Staffreviewel revisions 2-1483

571 - Total Lots 199.95 Acres SCALE = /"= 200 DATE = 3-31-80 REVISION =

Reference is made to the Vista P.O.A.D.P. (File #83-19-64-62) submitted for staff review. A joint review of this plan has been exercised by Planning and Traffic Engineering staff. Specifically, the analysis concentrated on areas for which plats have not been approved or recorded.

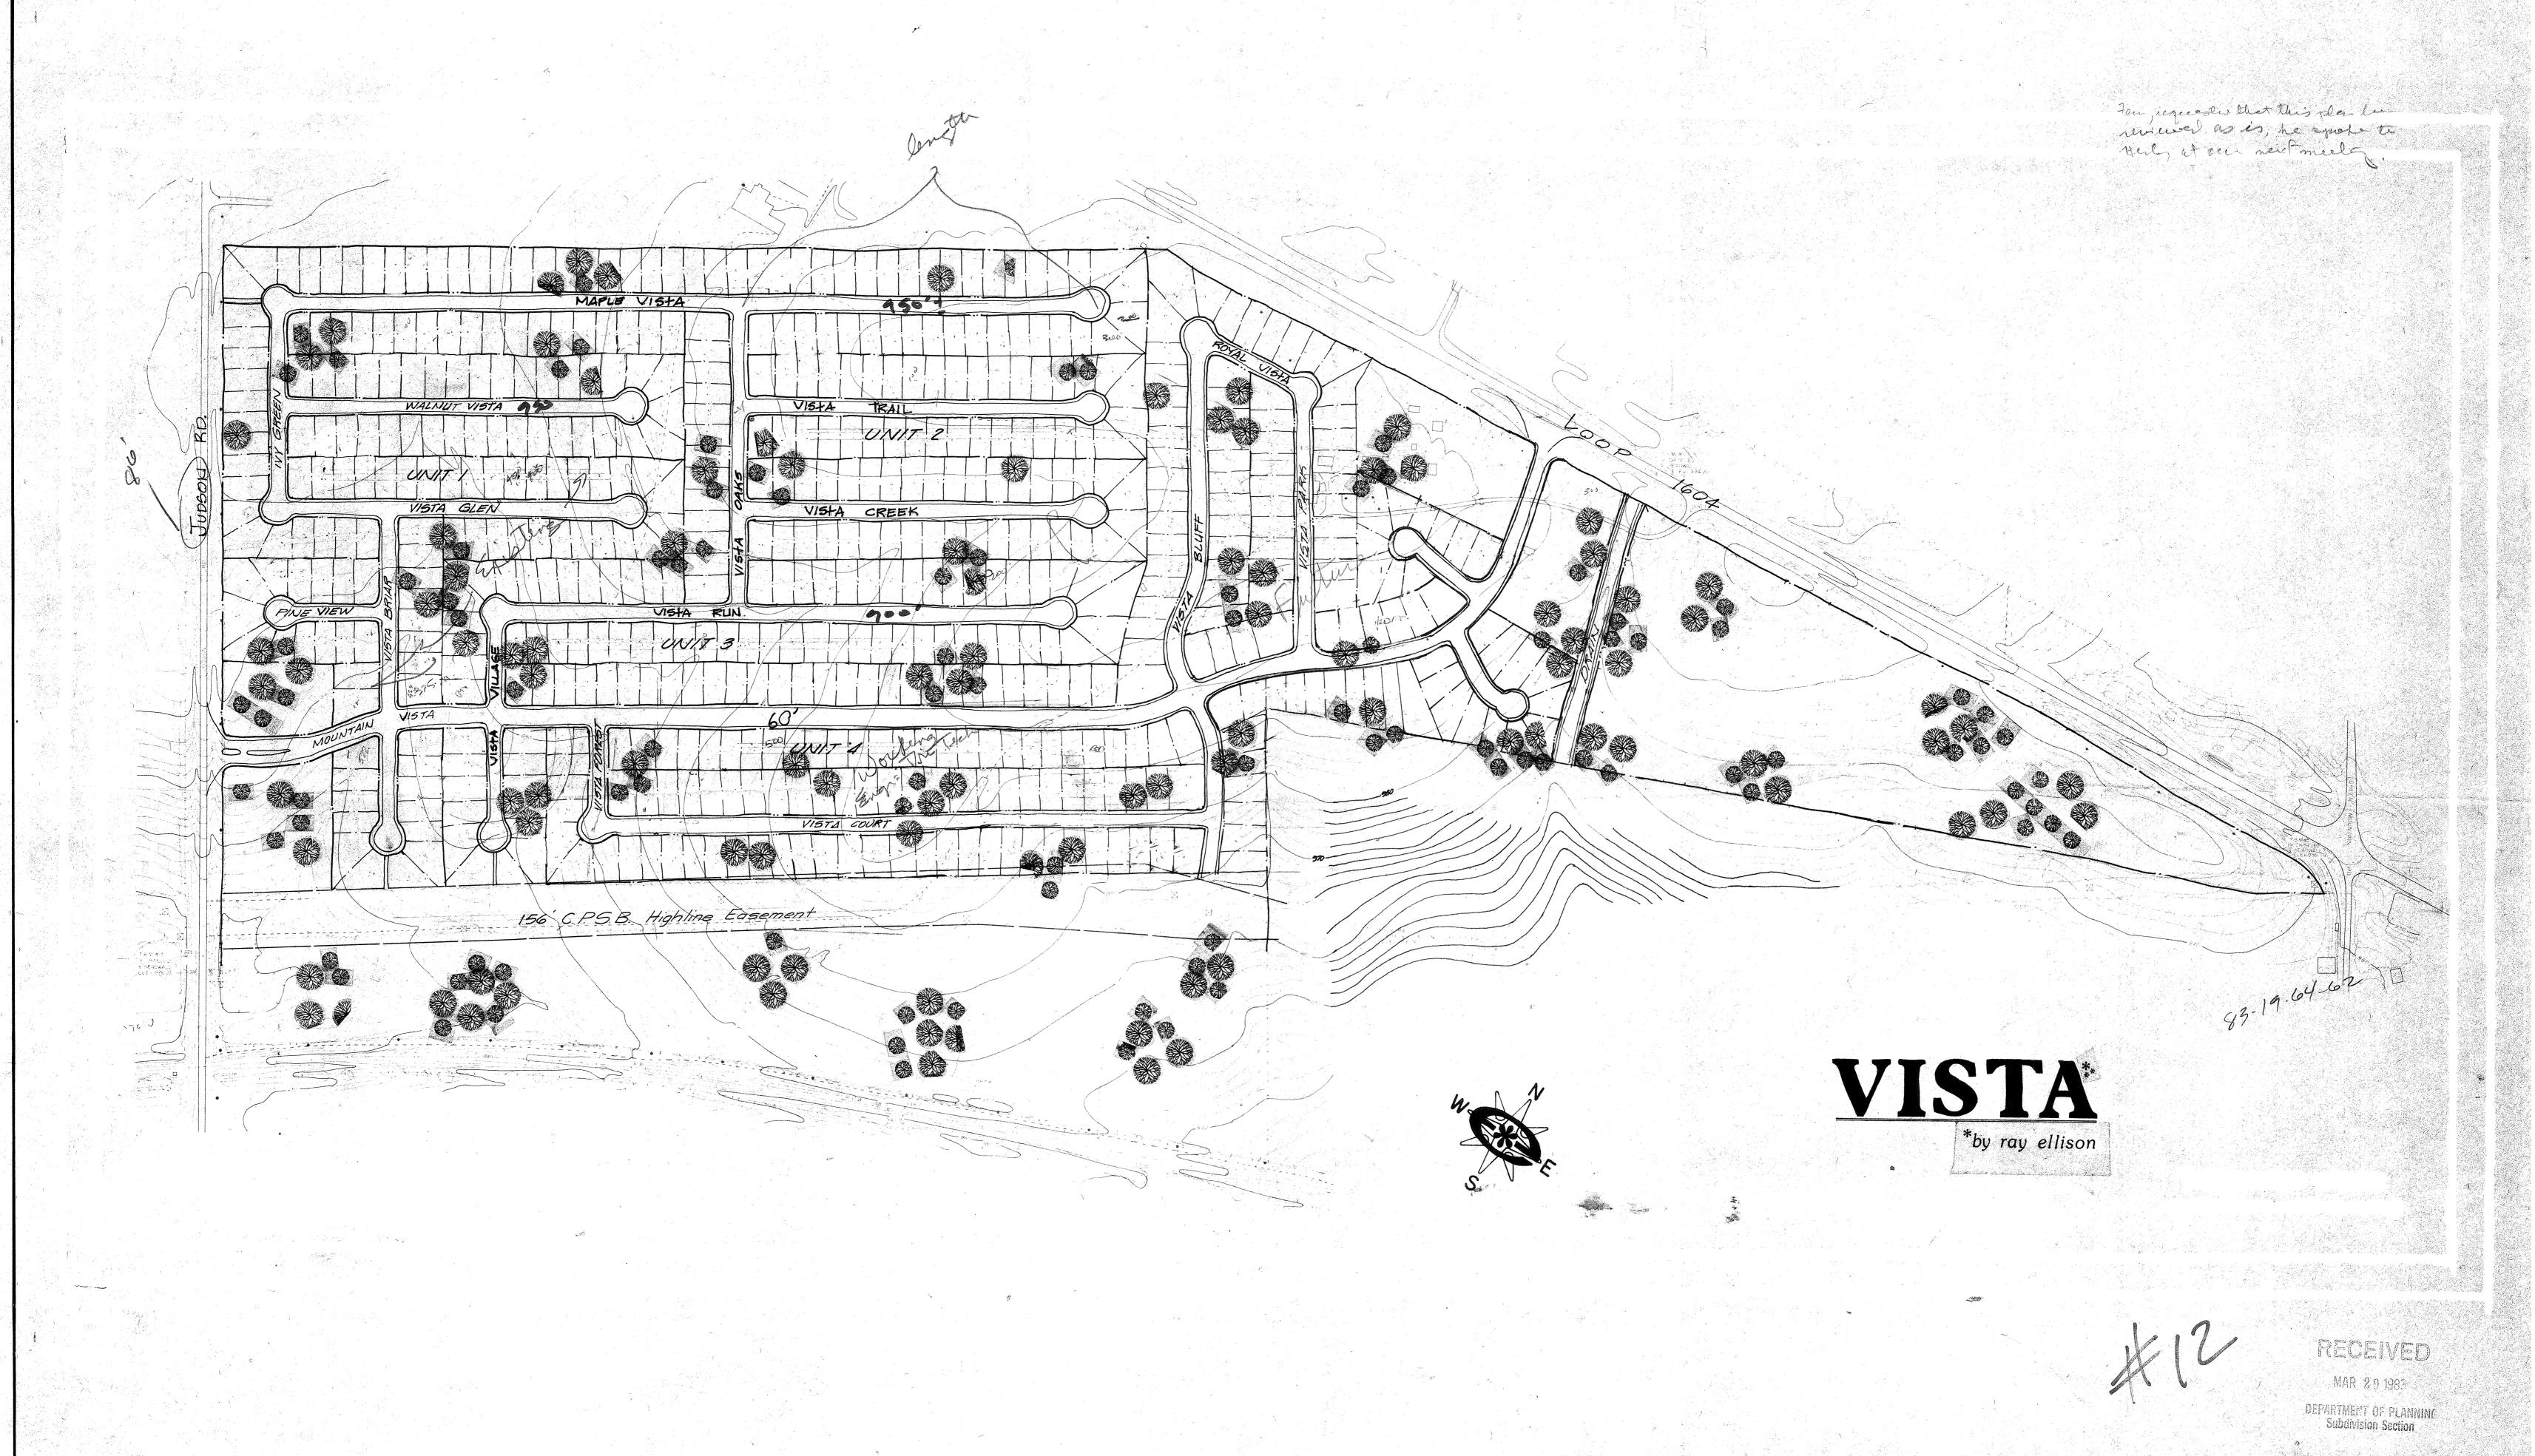
(X) Comments: Staff has reviewed the amendment to the POADP, and no objection

April 11, 1983.) regarding cul-de-sacs and Major Thoroughfare Plan.

is imposed. Note, prior written comments still apply (See letter dated

It has been concluded that the plan is in general compliance with Chapter 36 of the City Code. However, some cul-de-sac streets are in excess of 500' as referenced in Sec. 36-10(H) of the City Code. To address these situations, it is recommended that the cul-de-sac lengths be reduced to 500' or as an alternative, that street connections be made between parelling cul-de-sacs to break the excessive lengths. The latter alternative would result in a "U" shape design. If you elect to retain said cul-de-sacs as designed, it will be necessary for you upon application of a Letter of Certification from the Department of Public Works to address in writing the facts which warrant the proposed design. As you know, the Commission will accept or reject a plan with longer cul-de-sacs based on its merits after considering density, landuse, safety and convenience. In addition, it is noted that Judson Road is classified as a secondary arterial type "A" street (86' R.O.W.) on the Major Thoroughfare Plan. Any platting contiguous to said thoroughfare will require dedication for street widening in accordance with said thoroughfare plan.

It has been concluded that the plan is in general compliance with Chapter 36 of the City Code. However, some cul-de-sac streets are in excess of 500' as referenced in Sec. 36-10(H) of the City Code. To address these situations, it is recommended that the cul-de-sac lengths be reduced to 500' or as an alternative, that street connections be made between parelling cul-de-sacs to break the excessive lengths. The latter alternative would result in a "U" shape design. If you elect to retain said cul-de-sacs as designed, it will be necessary for you upon application of a Letter of Certification from the Department of Public Works to address in writing the facts which warrant the proposed design. As you know, the Commission will accept or reject a plan with longer cul-de-sacs based on its merits after considering density, landuse, safety and convenience. In addition, it is noted that Judson Road is classified as a secondary arterial type "A" street (86' R.O.W.) on the Major Thoroughfare Plan. Any platting contiguous to said thoroughfare will require dedication for street widening in accordance with said thoroughfare plan.
